**Subject: April 2011 Inspection Report, Cameco Resources, Permits 603 & 633**

**APRIL 2011 INSPECTION REPORT  
DISTRICT 1/LAND QUALITY DIVISION**

**COMPANY:** Cameco Resources (CR), Highland Ranch, Permit #603  
& Smith Ranch, Permit #633

*Figure 3 – Concrete cap from Well #732*

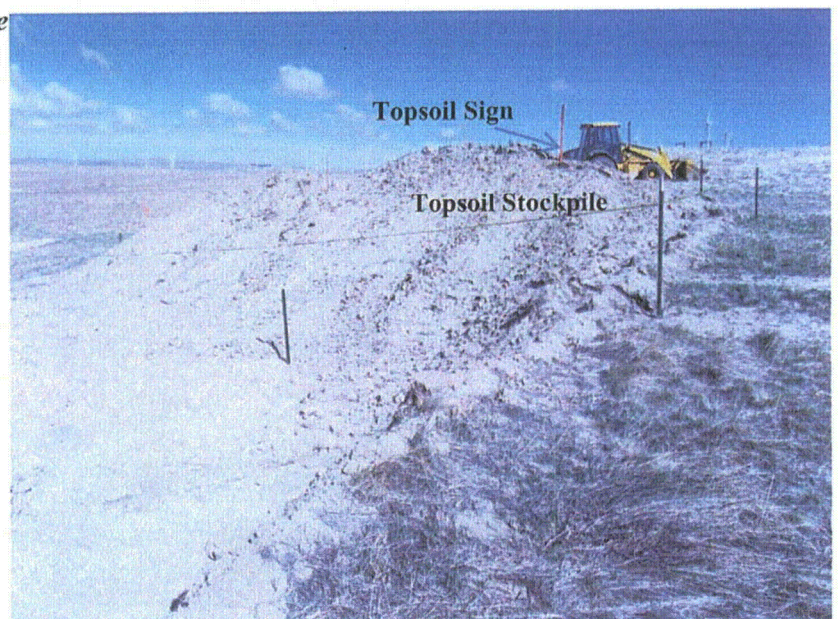
- MU-7 – Inspected holes #732, 793, 780, 704, 762, 2575 & 2521 (results are tabulated below in Table 1). Procedure for drill-hole inspection was to remove the soil cover with a backhoe or hand dig with a shovel, remove concrete cap, measure down to the plug with a 300' tape measure/probe, and replace concrete cap (**Figures 1-3**). None of the holes were in compliance with the two feet from surface requirement. Of the 20 holes inspected, 13 had the concrete plugs located and removed; 7 were not located. Of the 13 holes measured for depth to plug gel, all exceeded the required depth of two feet below surface. The depth varied from approximately 50 feet to 200 feet below surface. According to CR, they used a "plug gel"

**Figure 8** *Topsoil pile in MU-10 without erosion control or protection from mine disturbances*

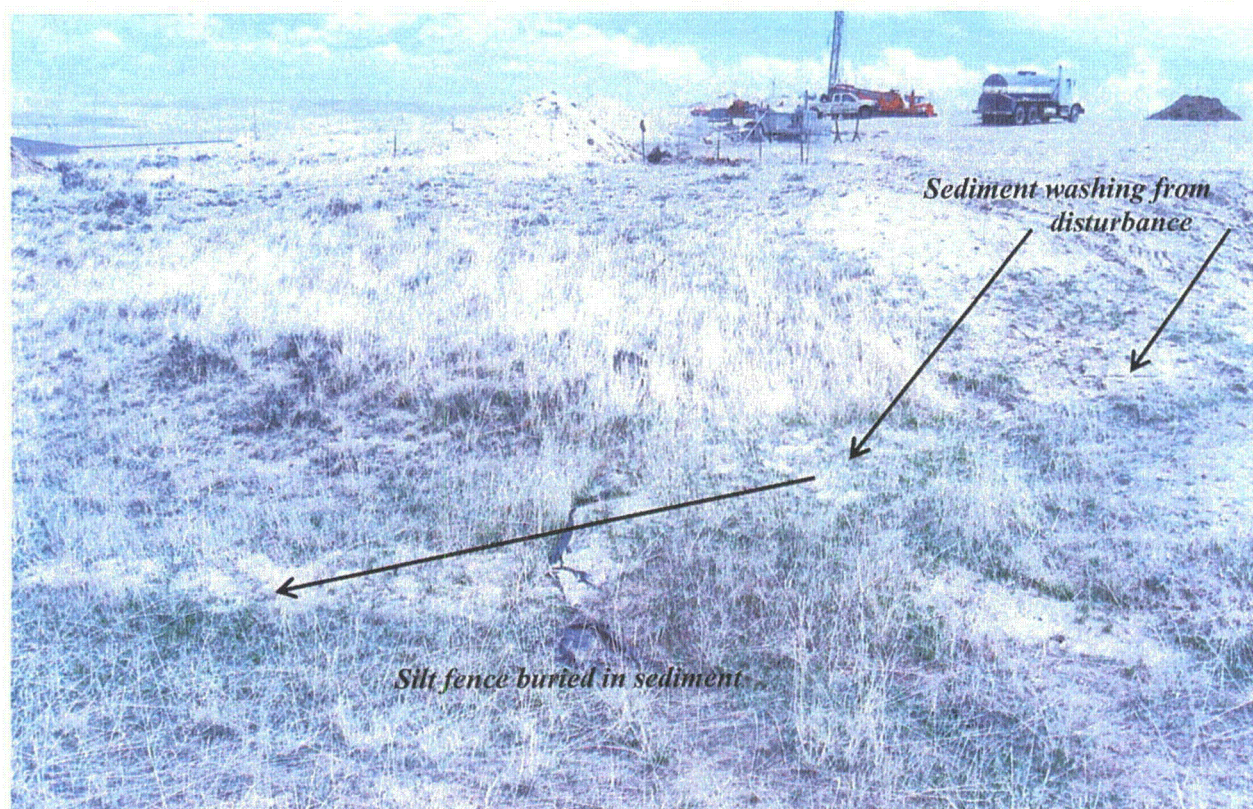
Topsoil piles in and around active drilling operations were inspected in proposed Mine Unit 10. The topsoil piles were absent of any erosion control protection (ditches/berms, wattles, seeding) (**Figure 7**). The topsoil piles were located approximately 20 feet from the drill sites on all the wells observed in the development area (approximately 10-15 sites). It was apparent that the piles were not being combined into a larger pile serving the area of disturbance as was discussed with CR to mitigate previous topsoil compliance concerns. The drilling supervisor indicated that the topsoil piles were not completed yet and they will be adding to them or combining piles. He stated that the piles will be complete sometime next week and erosion control will be added. The stockpiles were not only unprotected but also had vehicle disturbance due to the wellfield activity (**Figure 8**).
